UNITED STATES PATENT AND TRADEMARK OFFICE

APPLICATION NO.	FILING DATE	FIRST NAMED INVENTOR	ATTORNEY DOCKET NO.	CONFIRMATION NO.
10/807,213	03/22/2004	Chun Ta Lee		3301

Office Action Summary

DETAILED ACTION

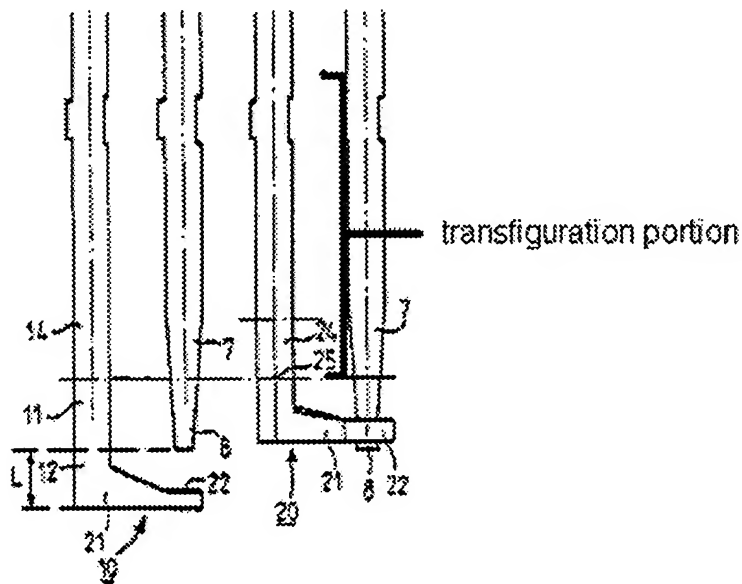
Regarding claim 3, Pernet discloses the second terminal comprises a second retaining portion connecting with the carrier strip, the cut out being on an edge adjacent to the first terminal (please note that the outer edge is still "adjacent"). Pernet discloses substantially the claimed invention except for the shape of the cutout. However, it would have been an obvious matter of design choice to form the cutout with a semicircular shape in order to simplify formation of the cutout, and since applicant has not disclosed that such shape solves any stated problem or is for any particular purpose and it appears that the invention would perform equally well with shape of Pernet.

Absent any convincing showing of the criticality of the design, this particular design is nothing more than the inventor's choice without thereby departing from the scope of the invention. *In re Dailey*, 149 USPQ 47 (CCPA 1976).

Regarding claim 4, Pernet discloses the second base section comprises a transfiguration portion (part at 24, see following figure), and an angled portion (at 21) interconnecting the transfiguration portion and the pressing portion.

Regarding claim 5, Pernet discloses the cut out being defined in the transfiguration portion (see previous figure).

Regarding claim 6, Pernet discloses the transfiguration portion being deflected outwardly (left in Fig.2b-1) for the position of the cut out.
